CITY OF SANTA FE
ENGINEERING DIVISION
PROJECT CHANGE ORDER #7

Change Order No. 7

Project No.: CIP #460B
Project Name: Santa Fe River Trail Connections and Improvements Project

ON: 8/20/2014 Sheet 10-1

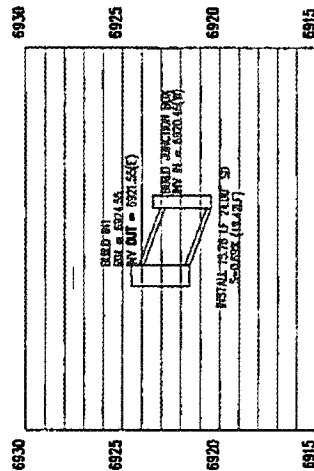
To delete item number 416000 (Minor Paving), 623311 (CDI Type I-B), and 570024 (24" Culvert Pipe) from the project's scope of work. Deleting these items removes any minimum testing required for the items including R value testing required under general note # 20 in the plans.

The City relocated CDI prior to construction using City Funds. Minor paving is getting deleted from the contract via this change order #7. The deletion will be reflected in the over/underrun change order as well. The intent of general note #20 was to have an "R" value of 40 for the minor paving portion of the project for relocation of the CDI. Being that the CDI was relocated the R-Value note will also require deletion. According to the NMDOT the R-Value is a pavement structure specific test and only applicable to curb and gutter. In section 608 (Sidewalk) of the 2014 NMDOT Standard Specifications "Natural Ground Density" is called out, not section 207 (Subgrade Prep). Furthermore R-Value is not mentioned in section 203 (Excavation, Borrow, & Embankment). The only mention of R-Value is in section 207 where subgrade prep is performed for roadway from back of curb to back of curb or end of taper to end of taper. The borrow that was brought in for the project was outside of the roadway and is not expected to experience traffic loadings. The City also relocated the 24" Culvert Pipe item along with the CDI prior to construction. *See sheet 10-1 Attached.*
